Eden Prairie: April 9, 2015

**Southwest LRT
Station Design Open Houses
Comments Received**

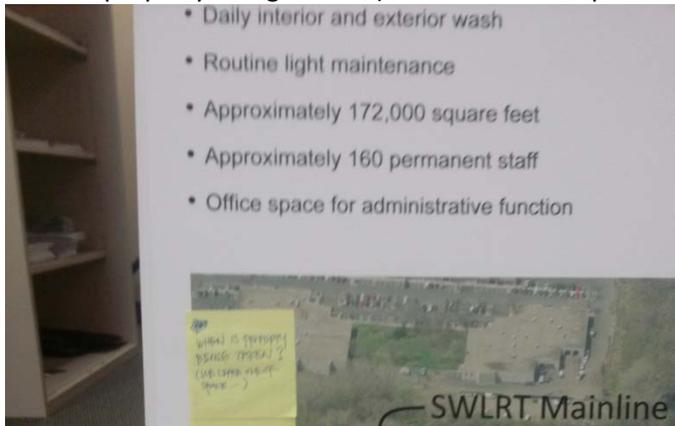
I am looking for temp bicycle storage

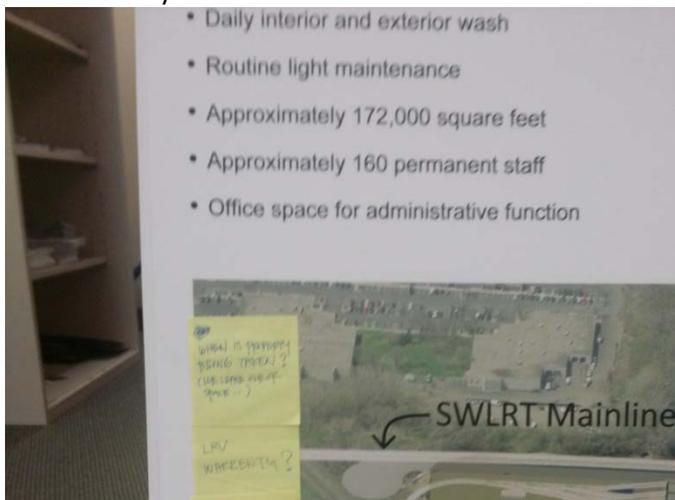
LLRV warranty?

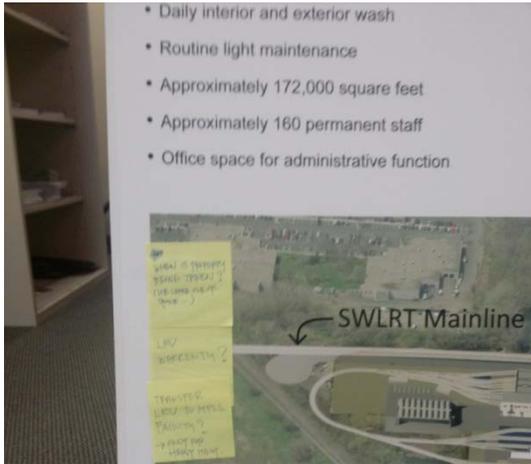
Transfer LRV to Mpls. Facility? Only for heavy maint.

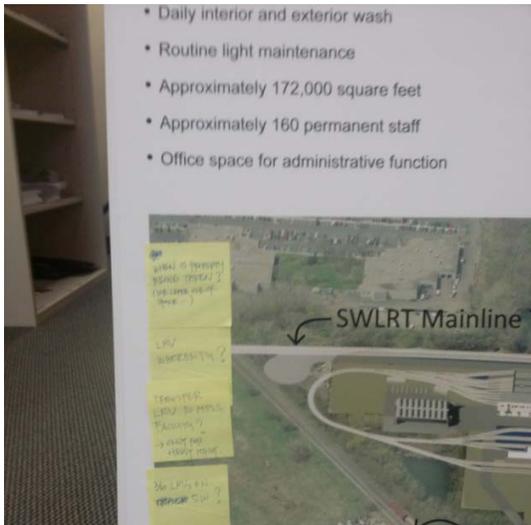
36 LRV's on SW?

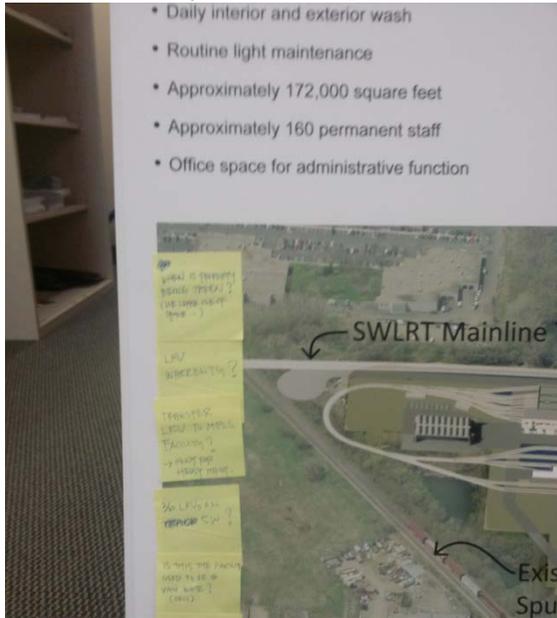
Is this the facility used to be @ Van White (DEIS)?

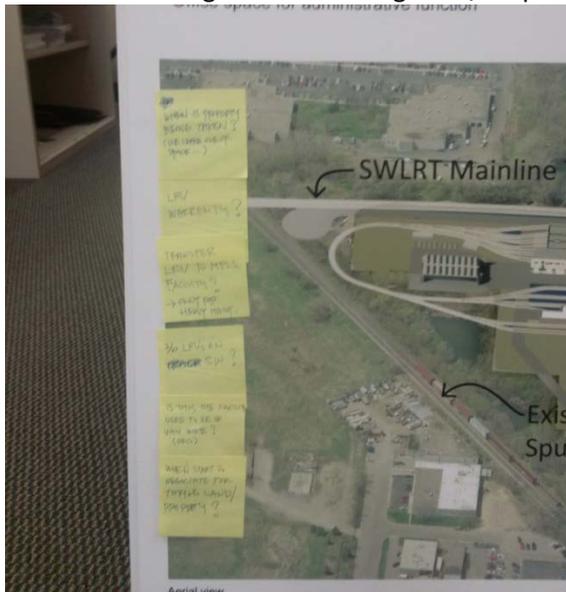
When start to negotiate for taking Land/Property?

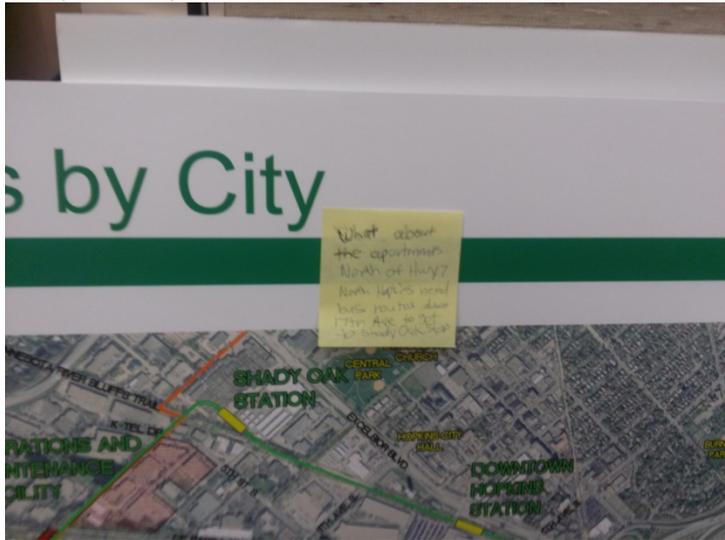
What about the apartments north of Hwy 7. North Hopkins needs bus routes down 17th Ave to get to Shady Oak stop.

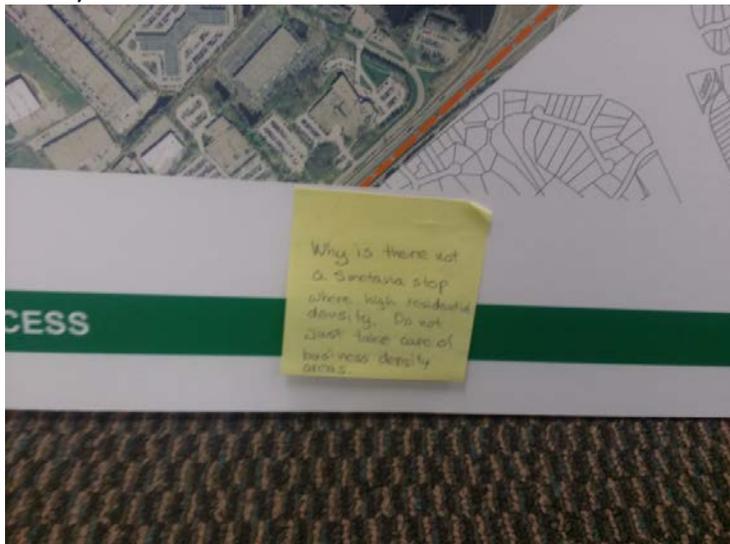
Why is there not a Smetana stop where high residential density. Do not just take care of business density areas.

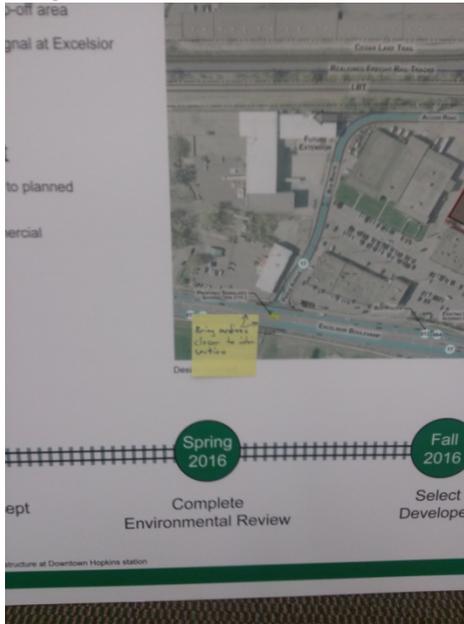
Bring medians closer to intersection

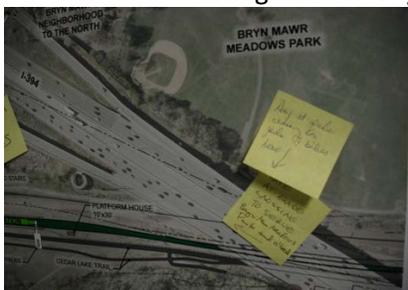
Safe At-Grade crossing to serve Bryn Mawr Meadows Park and n'hood

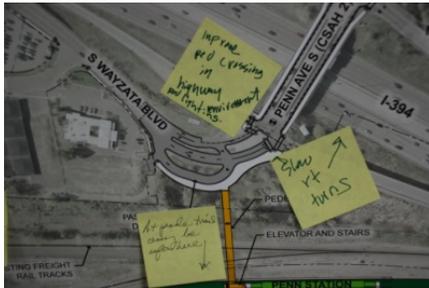
Bridges as art celebrate where they are

At grade crossing immediately west of platform- trains stopped

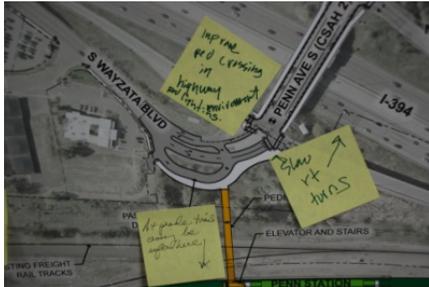
16
Slow rt runs

17
Improve ped crossing in highway red lighting environment

18
This should be a landmark

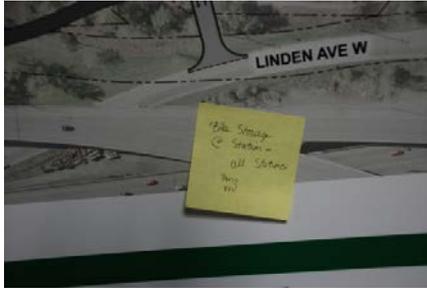
Roof with plants & soft curves in stations design – fold into landscape

Wheel-depth trench to reduce noise & profile

West Lake very close to housing- putting tracks below grade essential for noise mitigation & livability

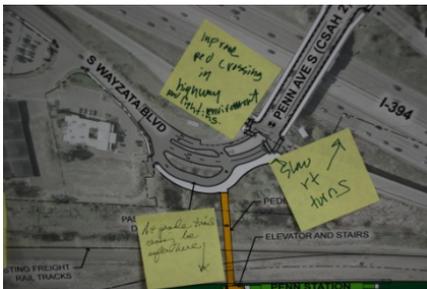
Bike storage @ station – all stations Penn view

At-grade trail crossing be safer here

Lott stations over here?

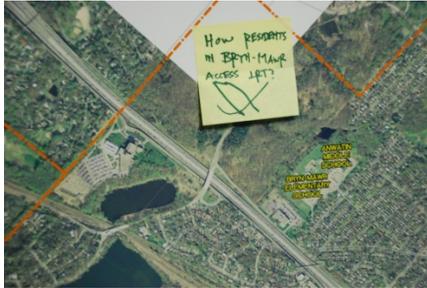
How residents in Bryn-Mawr access LRT?

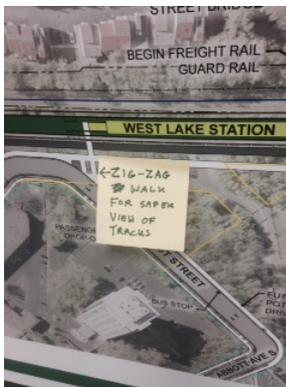
Zig-zag walk for safer view of tracks
